NOTICE OF DECISION

Friendsview Residential Care Facility Phase 1– Type 2 Design Review – File # DR221-0001

Friendsview Residential Care Facility Phase 1– Type 2 Design Review – File # DR221-0001

FILE NO: DR221-0001
REQUEST: Residential Care Facility with 79 patient units in a 4 story building of 73,000 square feet
LOCATION: 1301 E Fulton Street
TAX LOT: R3217CB 00200
APPLICANT: Friendsview Manor, Inc.
ZONE: I (Institutional)
PLAN DISTRICT: PQ (Public/Quasi-Public)
OVERLAYS: SC (Stream Corridor), Airport Overlay (Airport Inner Horizontal Surface)

A5 - TYPE II SITE PLAN REVIEW

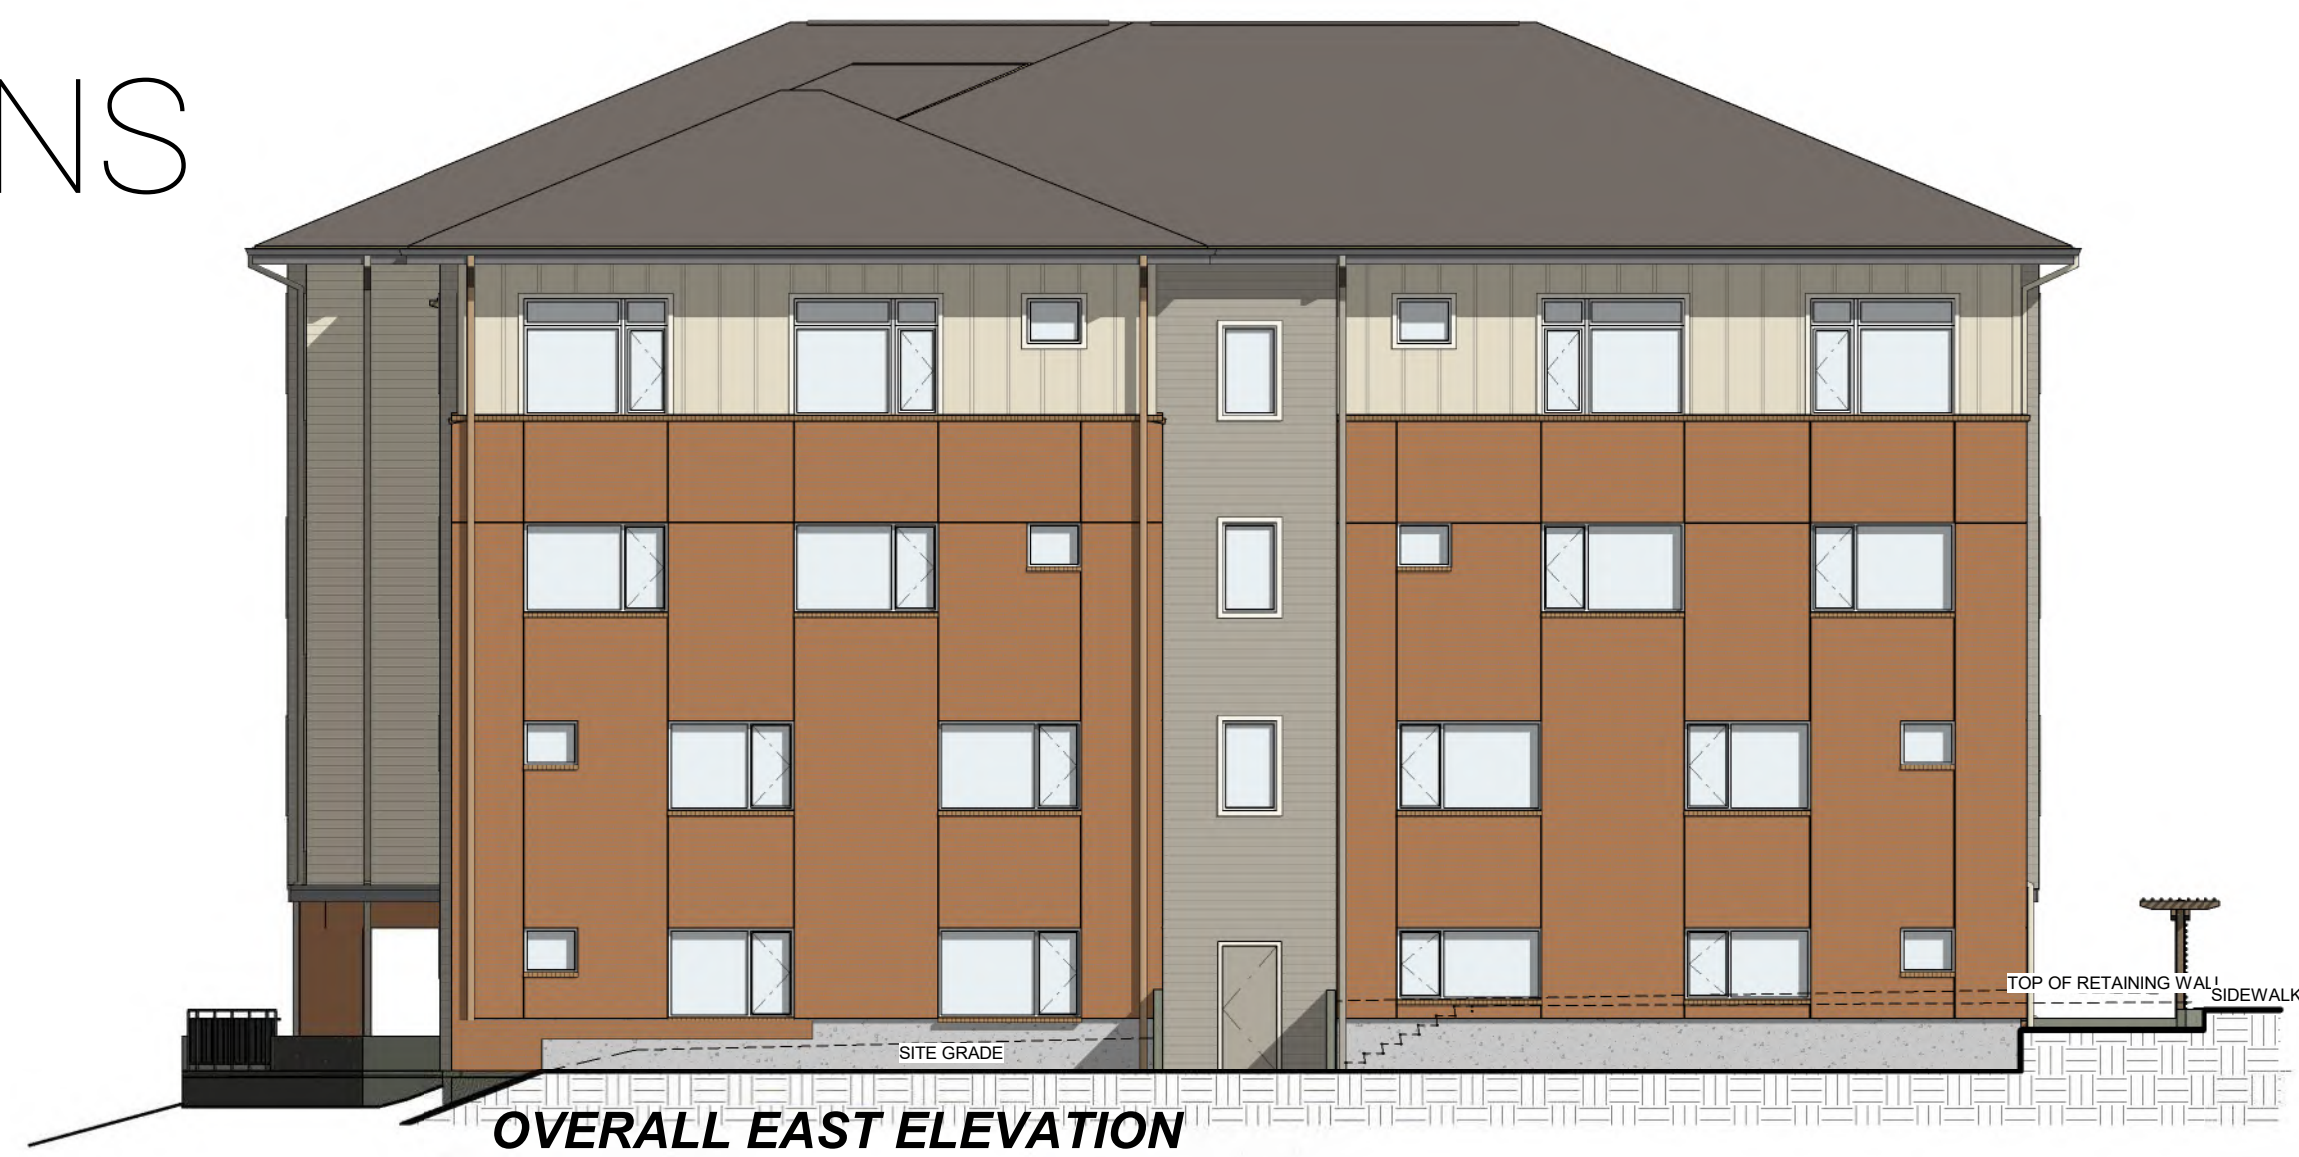
Finding: The applicant did not state in their narrative the actual height of the building but referred to plan sheet A5. Plan sheet A5 does not have a graphic scale or the proposed height noted on the plans so a ruler was used to measure the height of the RCF building. As measured by staff the proposed RCF building will be approximately 59 feet in height at the peak of the roof, well under the maximum height of 75 feet. The applicant did not state the distance of the RCF building to the nearest property line. The City's GIS was used to estimate a distance of approximately 340 feet to the closest residentially zoned property (R-1) to the north. All other zoning districts listed in NMC 15.415.020(D) are located further away than the R-1 zoned property to the north of the development site. This criterion is met because the proposed building will not exceed the maximum height of 75 feet and is positioned approximately 340 feet from the closest applicable property line.
